JSP24-13 QUICK PASS CAR WASH

PLANNING REVIEW

Planning Review QUICK PASS CAR WASH

Review Date: November 7, 2024
Review Type: Revised Preliminary Site Plan Review
Project Name: JSP24-13: Quick Pass Car Wash
Plan Date: October 10, 2024
Prepared by: Lindsay Bell, AICP
Contact: E-mail: lbell@cityofnovi.org Phone: (248) 347.0484

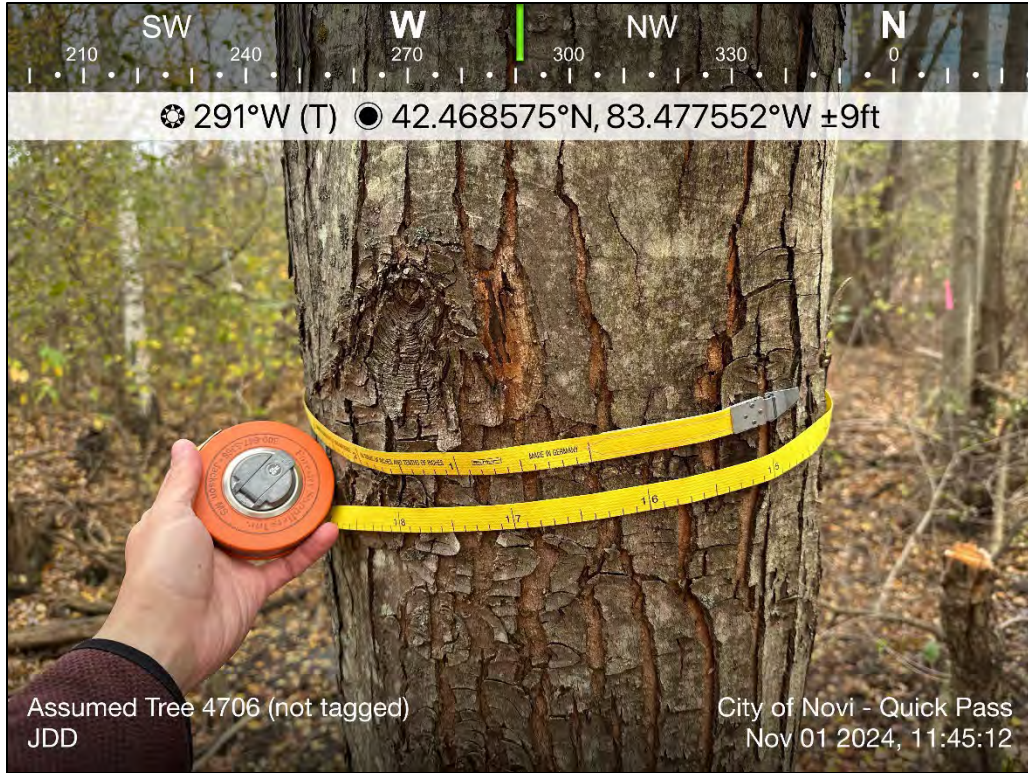
Assumed Tree 4704 with no tag (~14-inch *Ulmus americana*).

Assumed Tree 4705 with no tag (dual trunk ~9-inch *Morus alba*).

Assumed Tree 4706 with no tag (~16-inch *Acer saccharinum*).

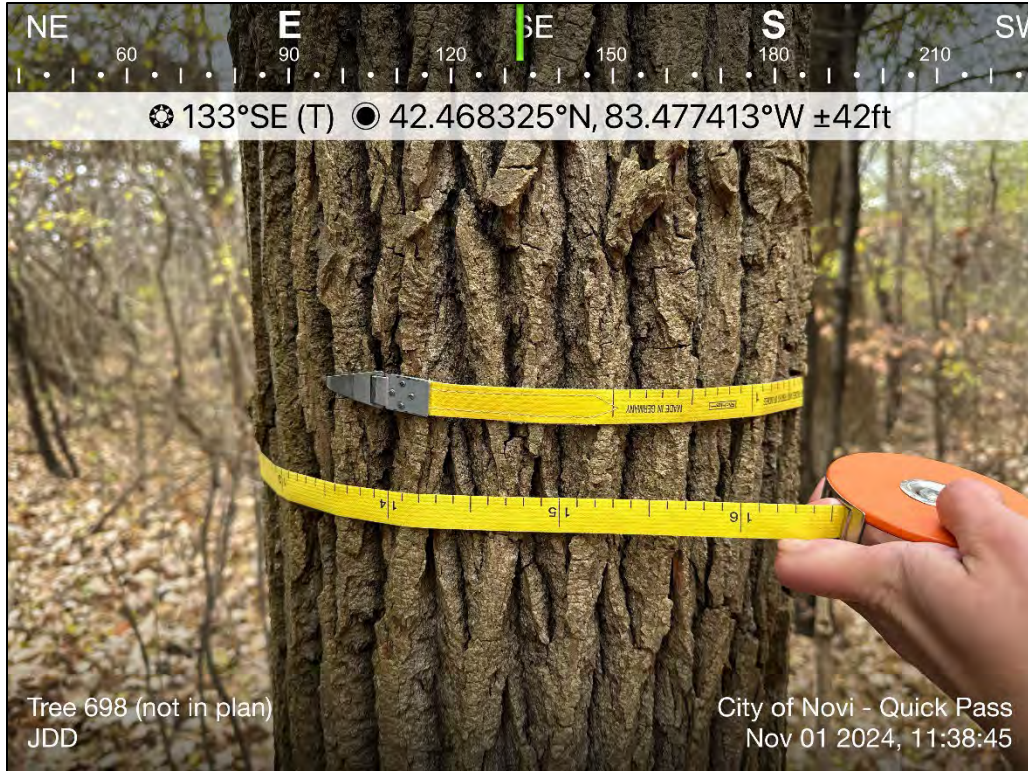
Assumed Tree 4707 with no tag (~9-inch *Ailanthus altissima*).

Similar to the PSP Review, very few tattered/ripped and unmarked flags were found on the ground from an old delineation.

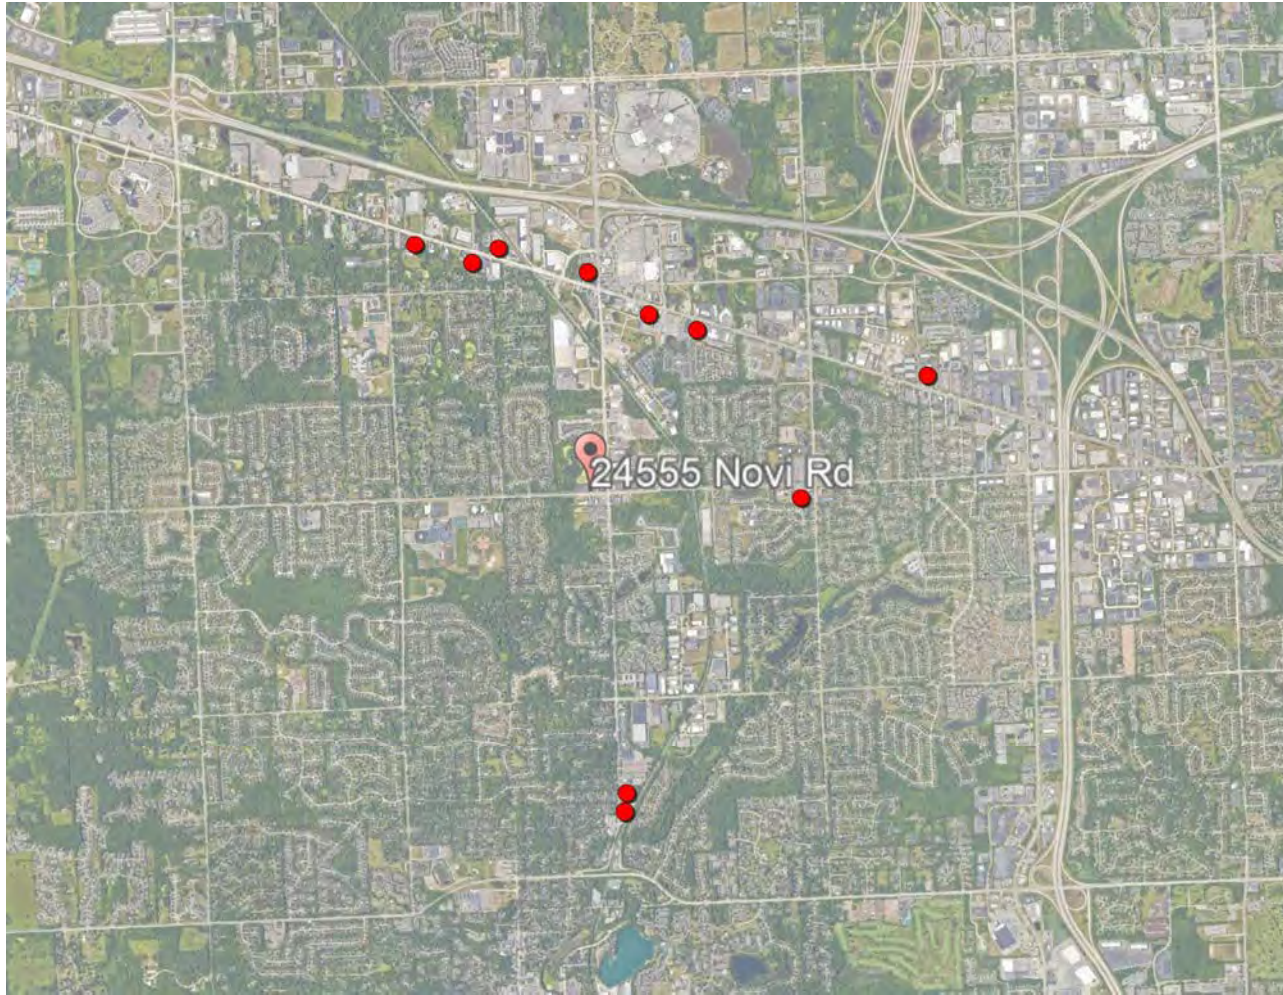
The Owners have chosen a mix of three beige C-Brick colors that have a natural color and would create a variation in tone. The façade review comments were that the C-Brick proposed does not have "rich dark earth-toned hues consistent with red bodies fired clay brick," which was not the Owner's understanding of the precedent provided by the façade consultant.

If nominal-size brick is used, it can potentially be any color, as none is defined in the zoning ordinance, yet if C-Brick is to qualify as brick, it must be red. It is the Owners'

contention that since they have selected C-Brick that has natural beige colors and a variation in tone, it would resemble a very common style and color of brick, even though it is not red. Full C-Brick sample boards will be brought to the meeting to demonstrate the actual proposed materials and colors.
